## **Proposal for amendments to Regulation No. 48 (Installation of lighting and light-signalling devices)**

The text reproduced below was prepared by the expert from OICA to present comments on the informal document GRE-67-04 submitted by Germany, regarding the discussion on marking of the cab of a motor vehicle, as agreed during the sixty-sixth session of GRE (see ECE/TRANS/WP.29/GRE/66 para. 7).

**Figure 1 Overall length excluding the drawbar**

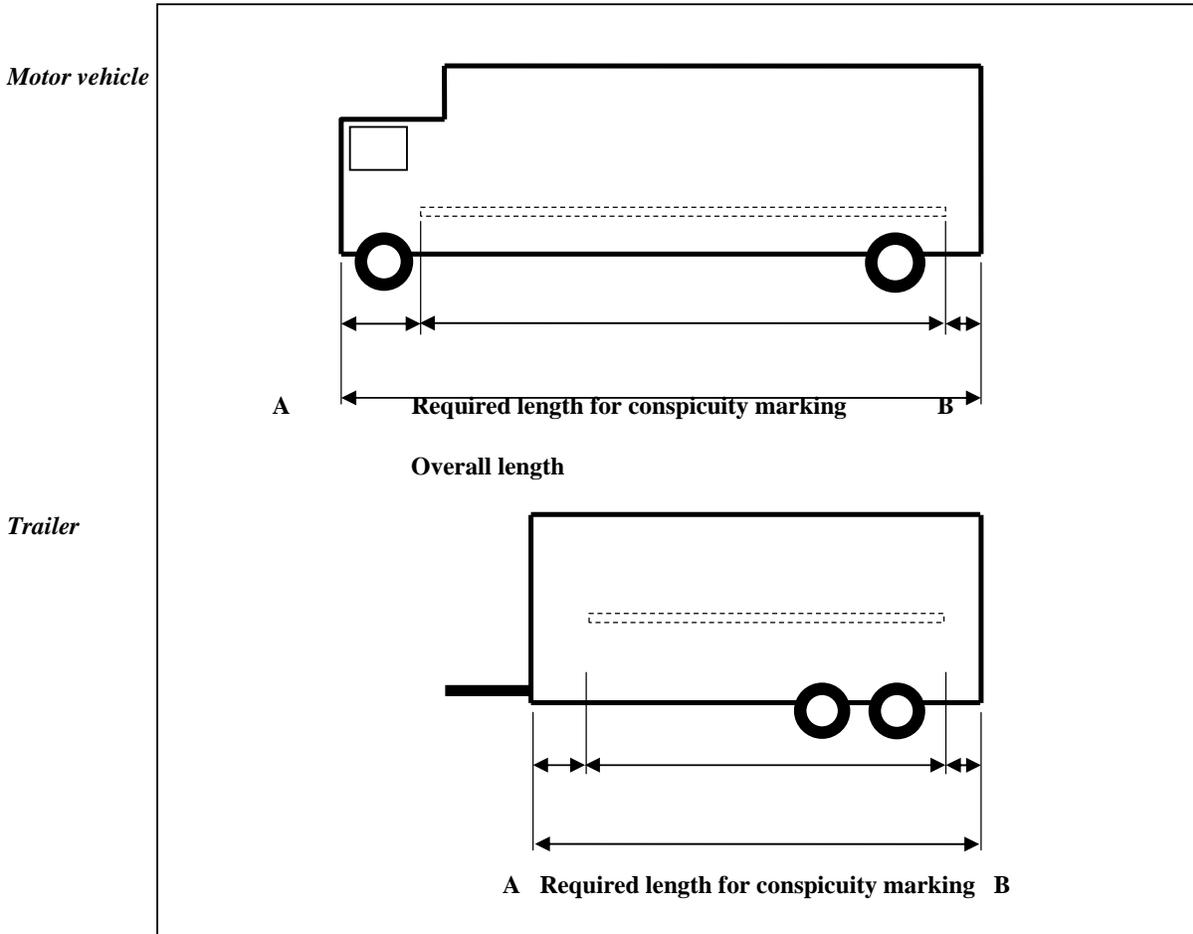
**2.7.17.4 "Unmarked front" (A in drawing ??), is the distance between the foremost conspicuity marking and the front end of the vehicle (in case of trailers excluding the drawbar). The maximum value is 600 mm as described in paragraph 6.21.4.2.1., or alternatively [~~1.800~~ **2.400**] mm for motor vehicles if paragraph 6.21.4.2.1.1.is fulfilled.**

**2.7.17.5 "Unmarked end" (B in drawing ??), is the distance between the rearmost conspicuity marking and the rear end of the vehicle. The maximum value is 600 mm as described in paragraph 6.21.4.2.1.**

**6.21.4.2.2.3. The required length for conspicuity marking shall be determined as follows (see also figure below):**

- For a motor vehicle, the overall length of the vehicle minus the unmarked end and minus the unmarked front;
- For a trailer, the overall length of the vehicle excluding the drawbar minus the unmarked end and minus the unmarked front.
